Attachment C: Plan Comparison Table

Approved Plans	Proposed modification plans
Site Plan DA0350/2022 – Revision 3	Site Plan DAM0043/2024 – Revision 07

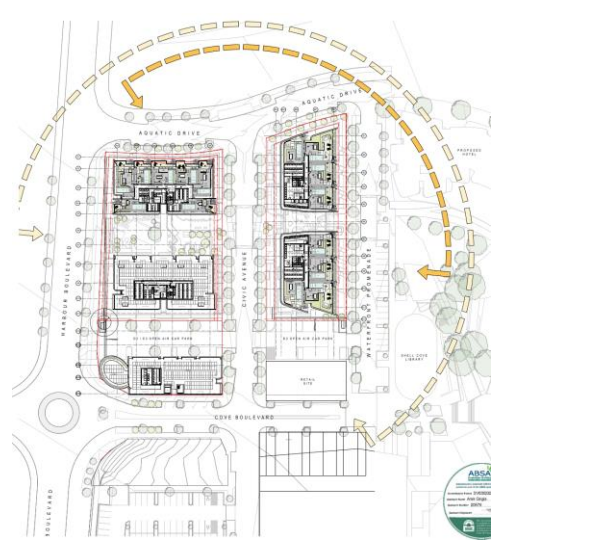
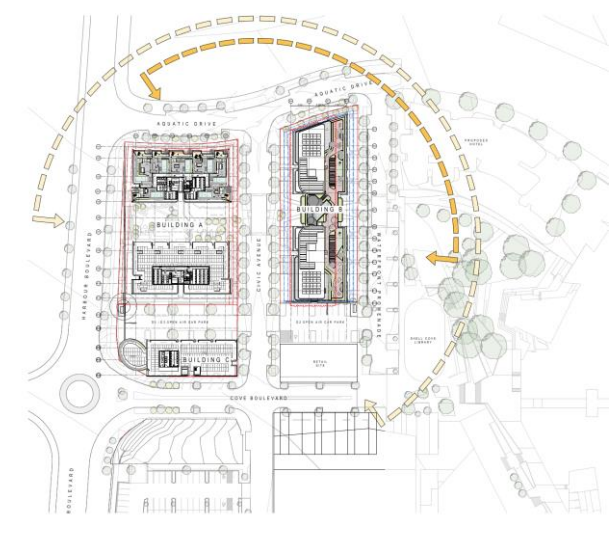
Comment: The modified site plan captures the changes to the façade, external built form, and communal open space on the top floor of Building B.

Basement 2 Overall Plan DA0350/2022 – Revision 13	Basement 2 Overall Plan DAM0043/2024 – Revision 17

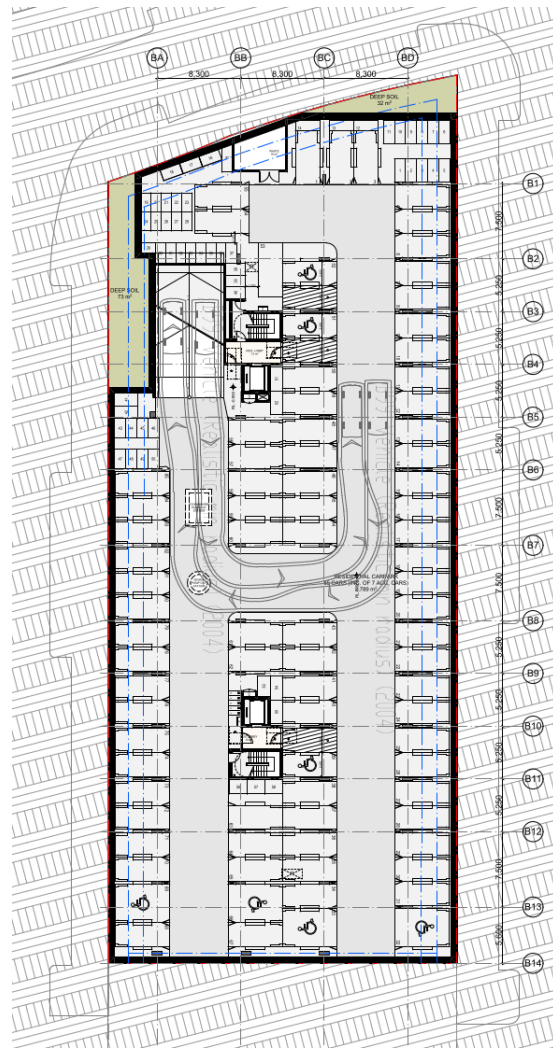
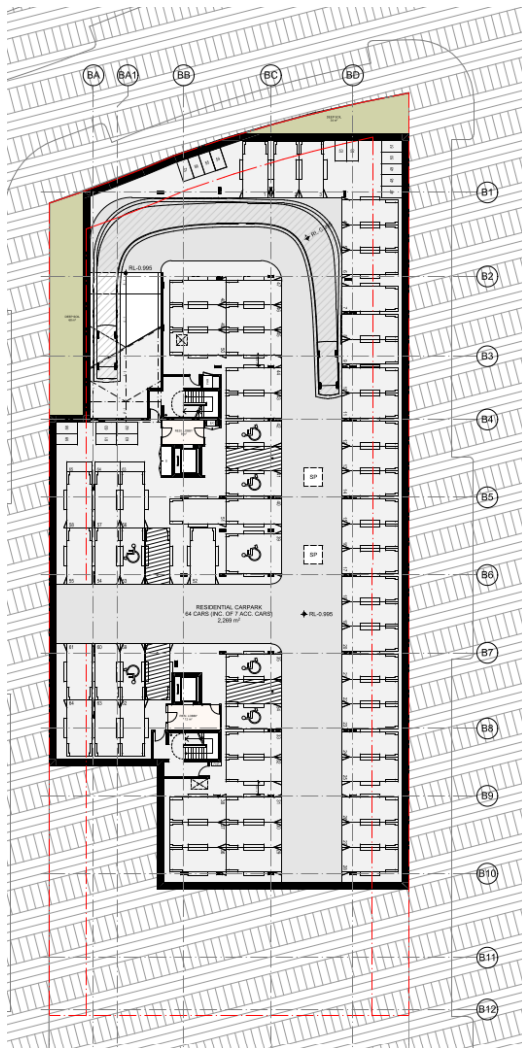
Comment: The proposed basement 2 overall plan captures the provision of additional basement parking, and a modified basement configuration. Of note, the basement entry is directed towards the centre of the build, and the basement floor area increases toward the south-east of the build.

Basement 1 Overall Plan

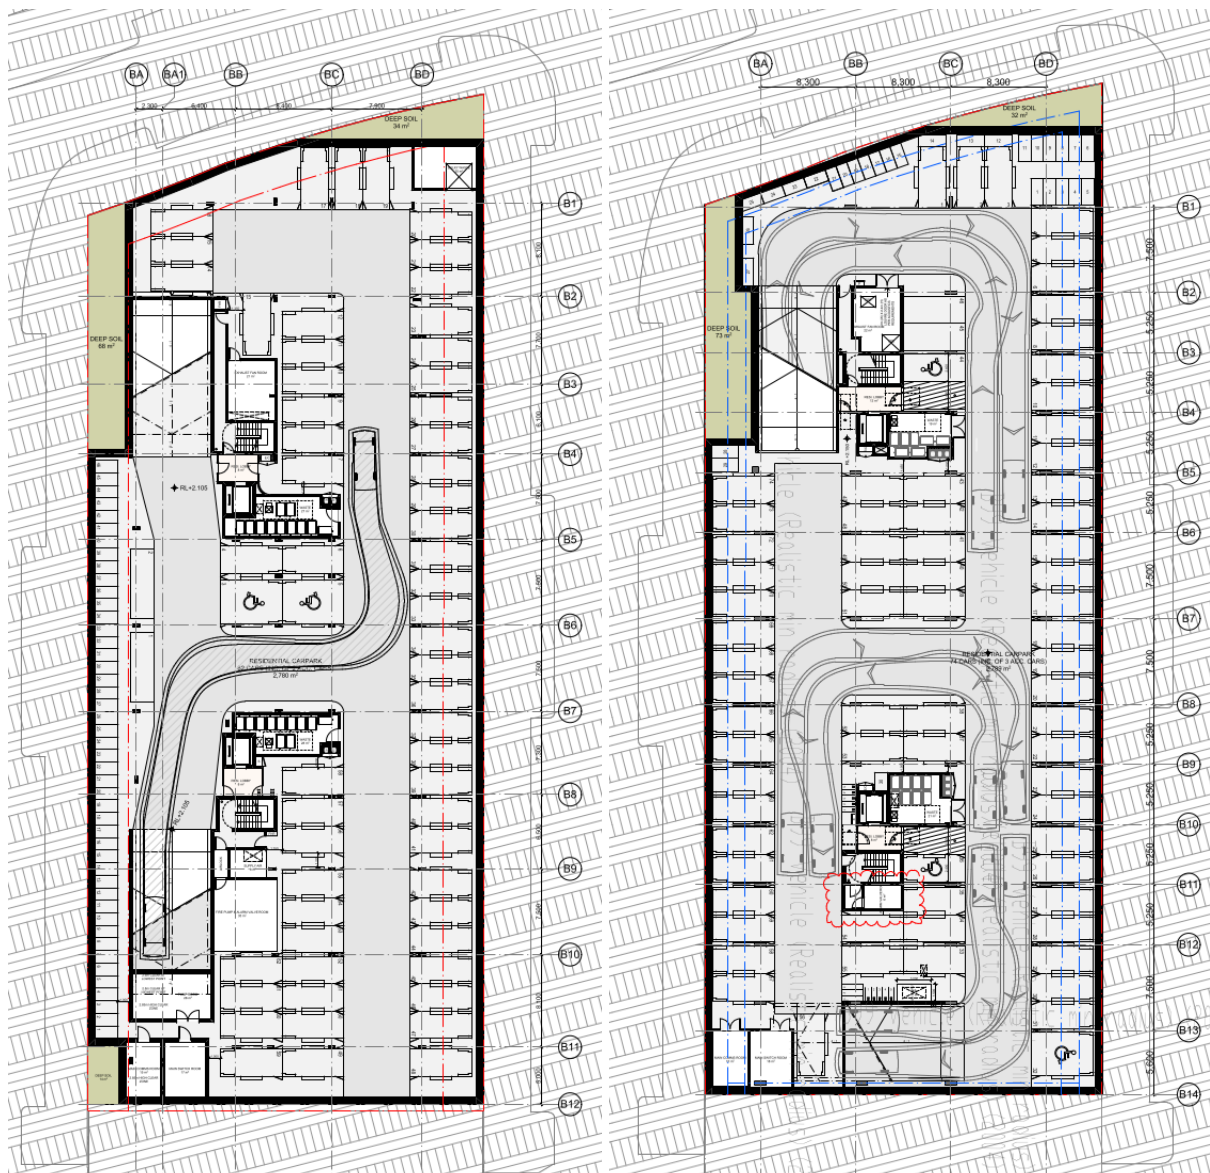
Comment: The Basement 1 Overall Plan captures changes to the basement configuration. Particularly, the entry access direction changes, as does the access to Basement 2. The west side of Building B features an additional row of parking, and the storage compartments have been relocated primarily toward the north side of the basement 1.

Ground Floor Overall Plan

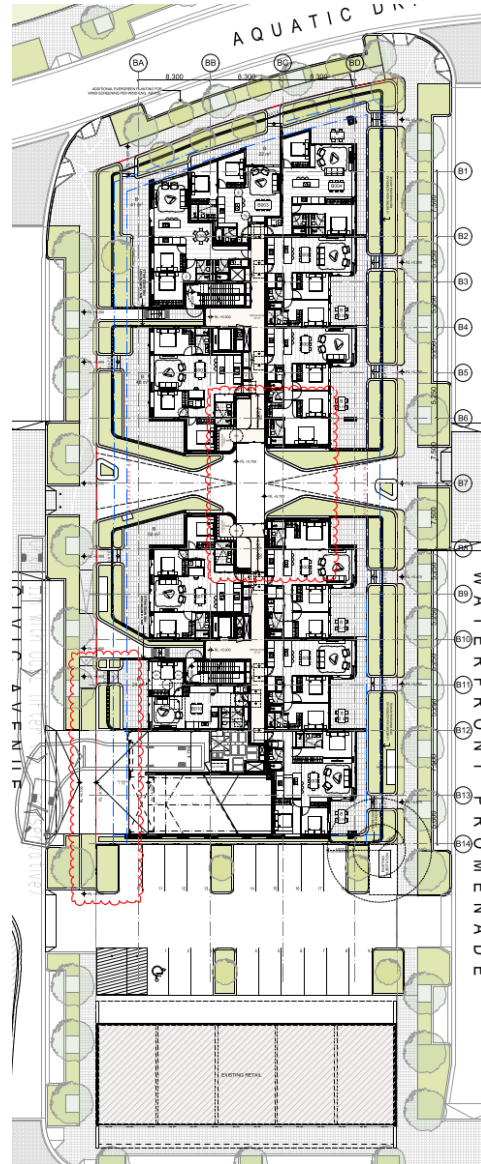
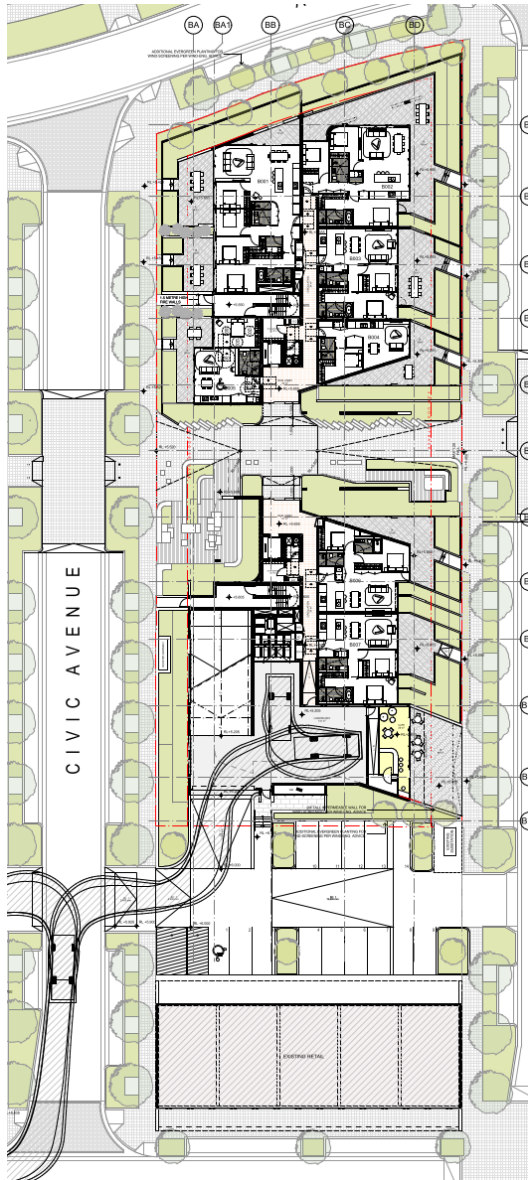
Comment: The modified ground-floor plan captures numerous details:

- The change in basement access from the open air carpark to Civic Avenue
- Change in design of the through-site access, between the north and south components of Building B.
- Change in the general floor plan configuration. This includes loss of communal open space in the south component (near the through-site access, and the cafe which was conditioned for use as communal open space. These features have been replaced with private apartment features).
- The total number of apartments on the ground-floor increases from 7 to 11

Level 1 Overall Plan

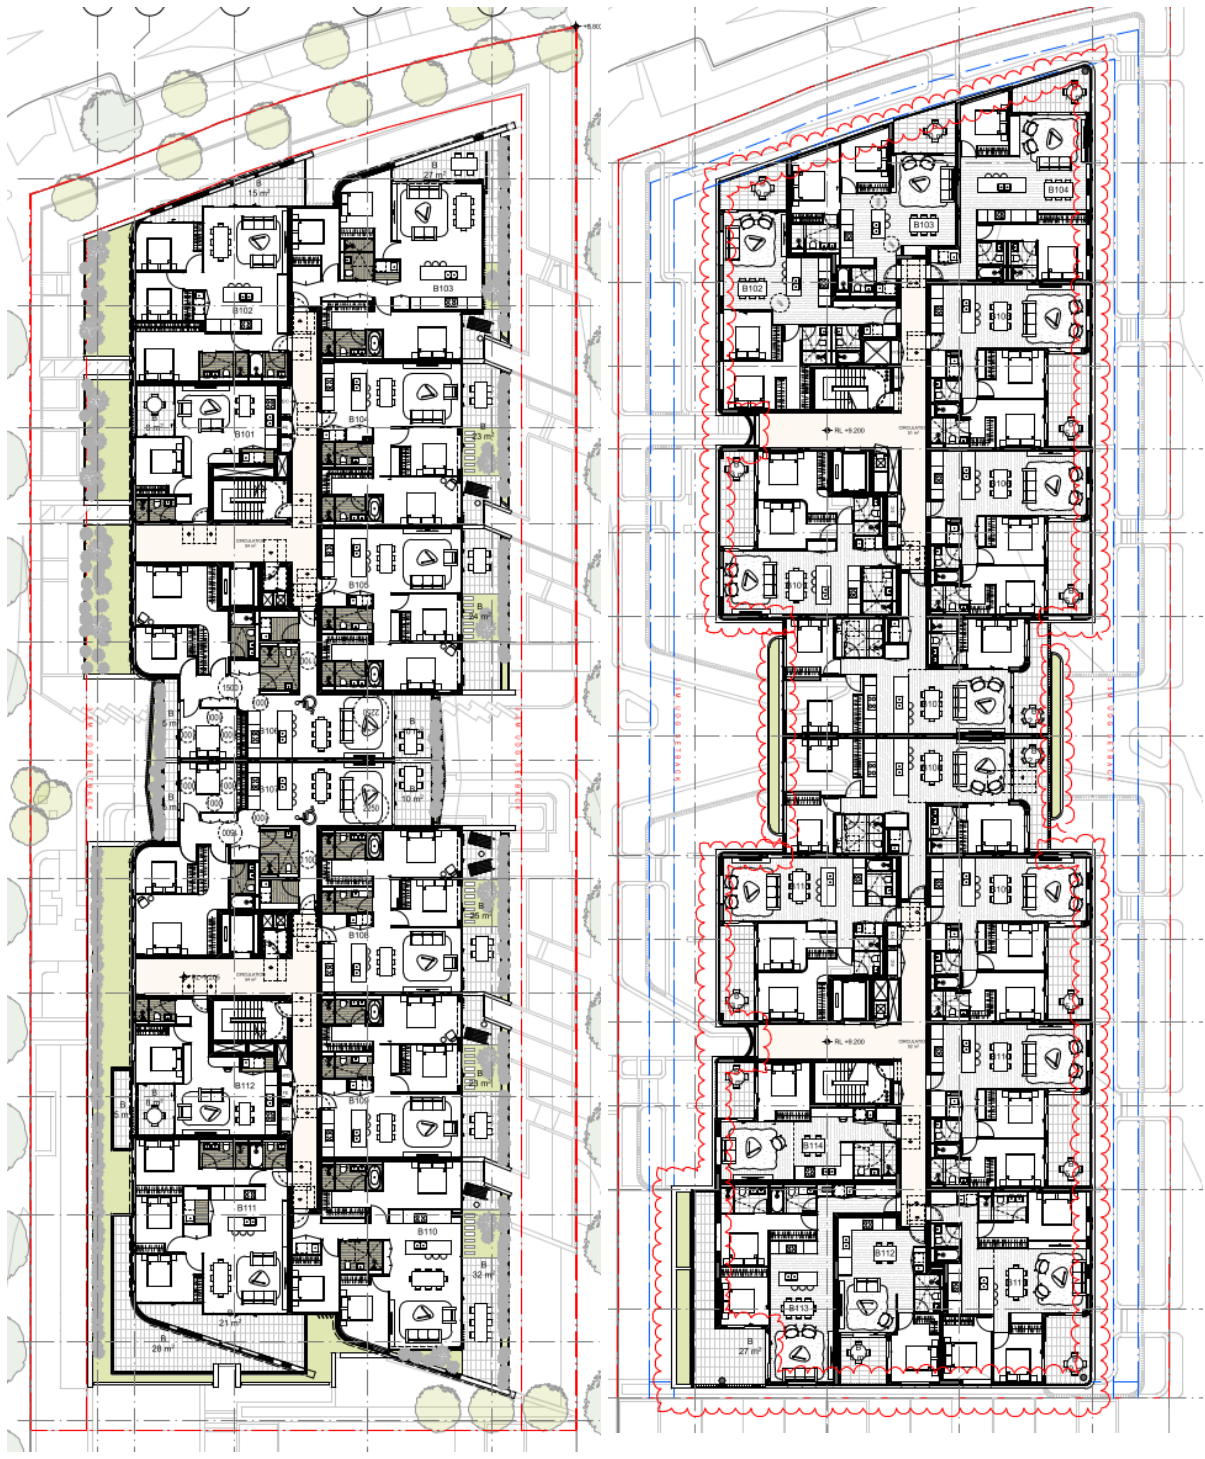
Comment: The modified Level 1 plan captures changes to the floor configuration, number of apartments, and façade details.

Level 2 Overall Plan

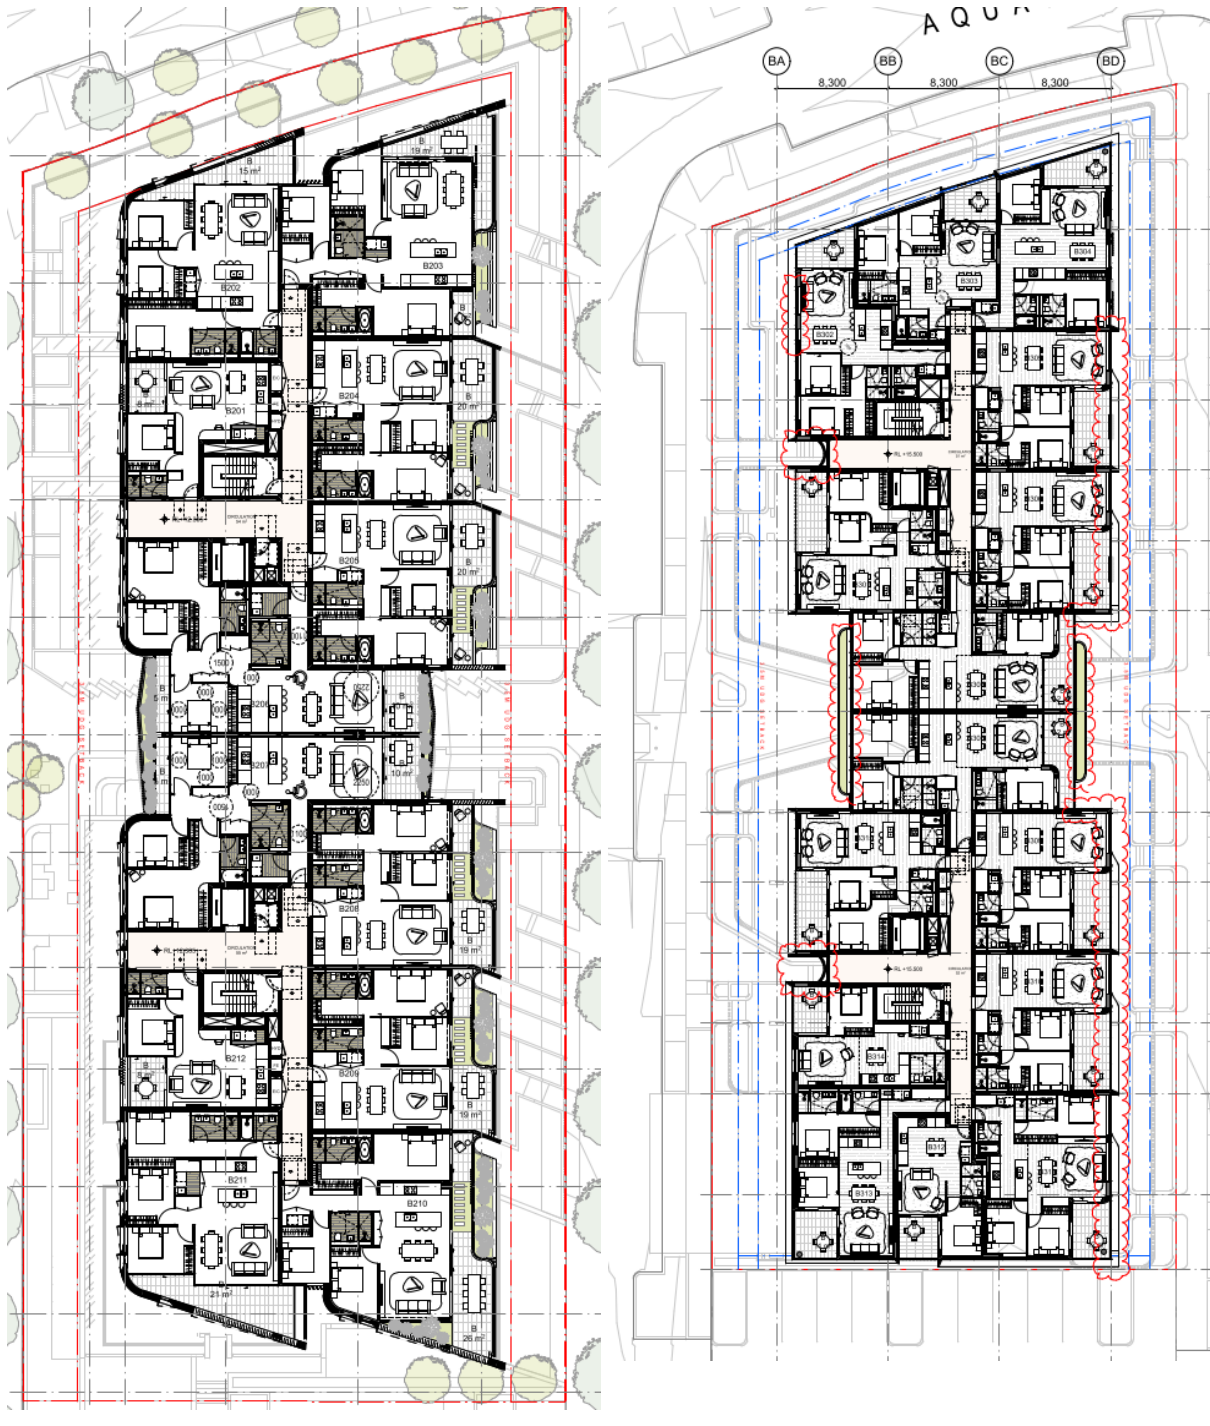
Comment: The modifications to the Level 2 floor plan capture changes to the floor configuration, increase in apartment numbers, and changes to the façade details.

Level 4 Overall Plan

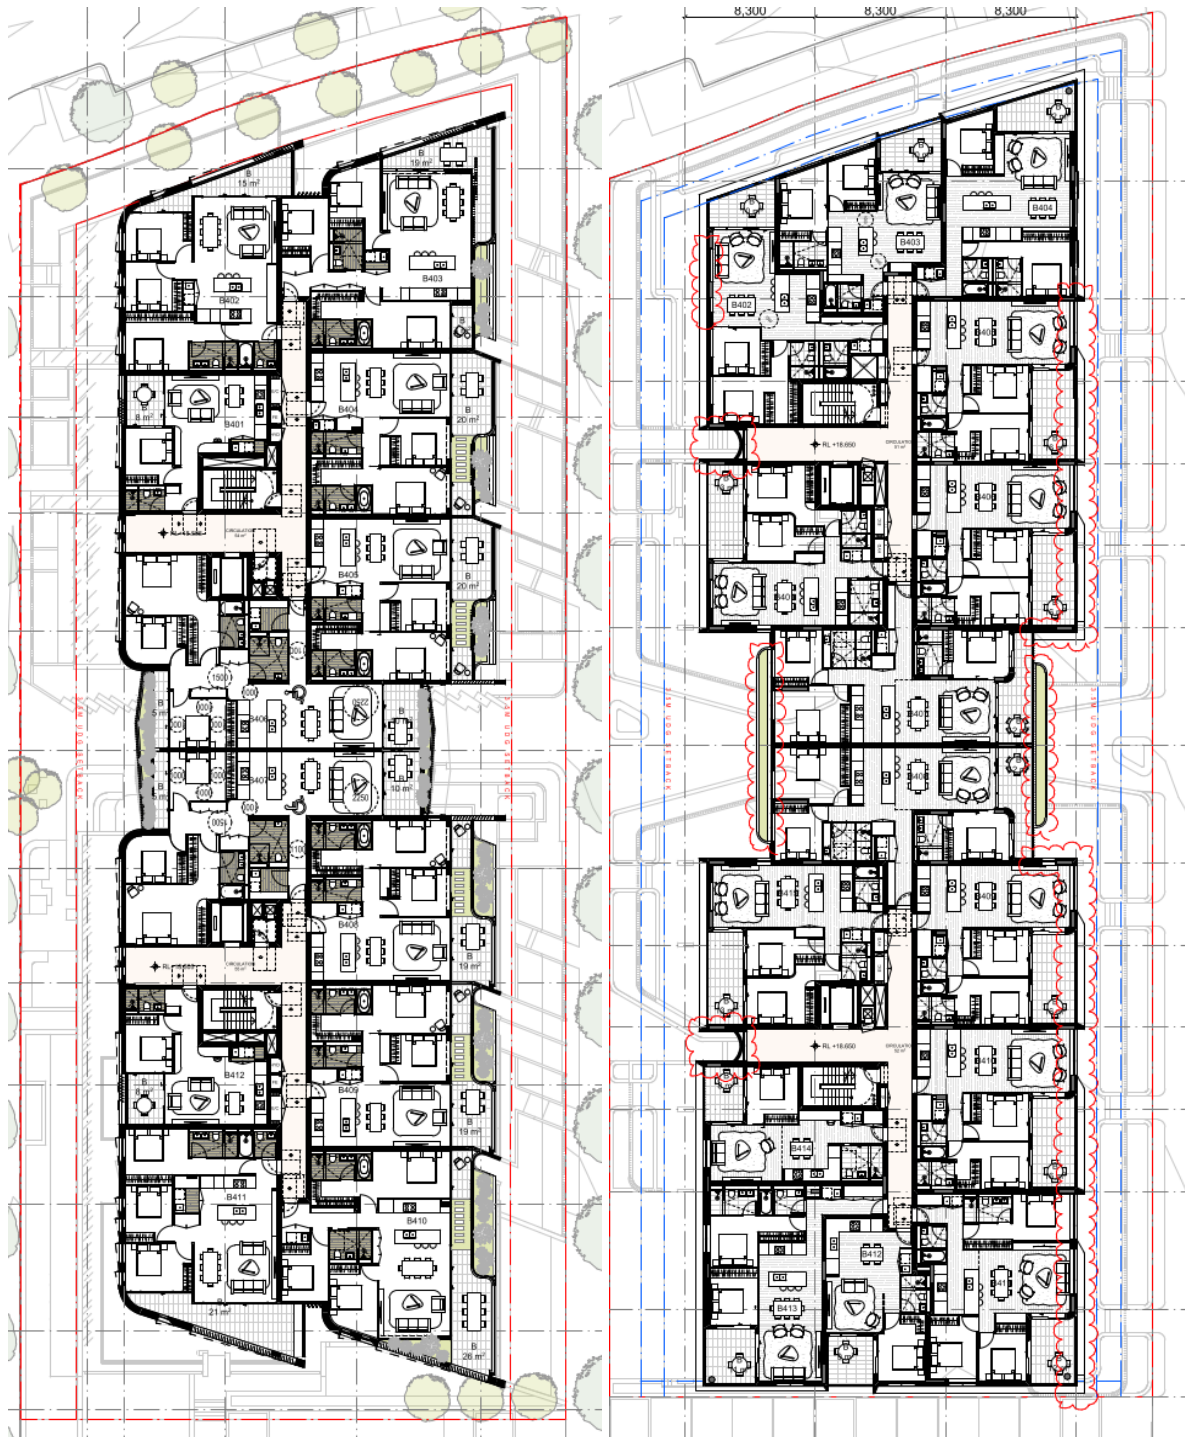
Comment: The modifications to the Level 4 floor plan captures changes to the floor configuration, increase of apartment numbers, and changes to the façade details.
